UNITED STATES PATENT AND TRADEMARK OFFICE

APPLICATION NO.	FILING DATE	FIRST NAMED INVENTOR	ATTORNEY DOCKET NO.	CONFIRMATION NO.
10/588,165	04/02/2008	Uri Arkashevski	MHEAT-006XX	5155
207 7590 10/15/2010 WEINGARTEN, SCHURGIN, GAGNEBIN & LEBOVICI LLP TEN POST OFFICE SQUARE BOSTON, MA 02109				
EXAMINER				
HWU, DAVIS D				
ART UNIT		PAPER NUMBER		
3752				
MAIL DATE		DELIVERY MODE		
10/15/2010		PAPER

Office Action Summary

DETAILED ACTION

Fig.5

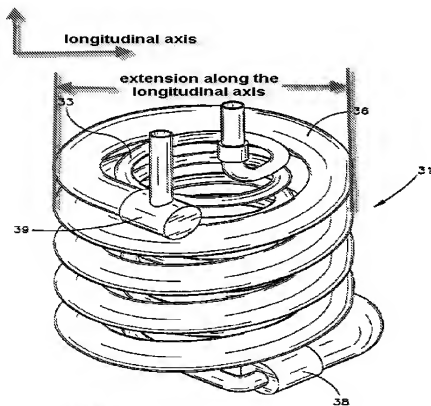
2. Claims 1-9 are rejected under 35 U.S.C. 102(b) as being anticipated by Shank et al.

Shank et al. show a windshield heated liquid spray assembly comprising: a liquid heating assembly 30; and a heated liquid spray assembly 34 and 37 to spray heated liquid onto a windshield, the liquid heating assembly comprising: a liquid heating chamber (column 3, lines 63-64); at least one heating element 33 disposed in the chamber; and at least one heat dissipater 36 in heat conduction contact with the heating element 33, the dissipater defining a liquid flow channel and being operative to transfer heat from the heating element to the liquid flowing through the liquid flow channel (column 3, lines 61-63); a liquid temperature sensor 18 as recited in claim 2. The couplings 38 and 39 provide a non-uniform section to the heat dissipater 36 as recited in claim 3. Regarding claim 4, the heat dissipater 36 extends a longitudinal axis and is aligned vertically wherein the couplings 38 and 39 provide non-uniform sections. The claim does not recite a reference to which the heat dissipater is aligned vertically with. Regarding claim 5, the liquid inlet into the heat dissipater 36 is considered to be an aperture that communicates with the liquid flow channel. Regarding claims 6 and 7, the

heat dissipater 36 is located within the liquid heating chamber as stated above, and the liquid flow channel within the heat dissipater defines a fluid flow gap, and since the heat dissipater 36 is coiled, it causes the fluid to flow in multiple directions. Regarding claim 8, since the dissipater 36 is a coil, it also extends in a longitudinal axis (see Fig. 5 below) and wherein the fluid flowing in multiple directions includes fluid flowing in opposite longitudinal directions along the longitudinal axis by virtue of the coiled configuration.
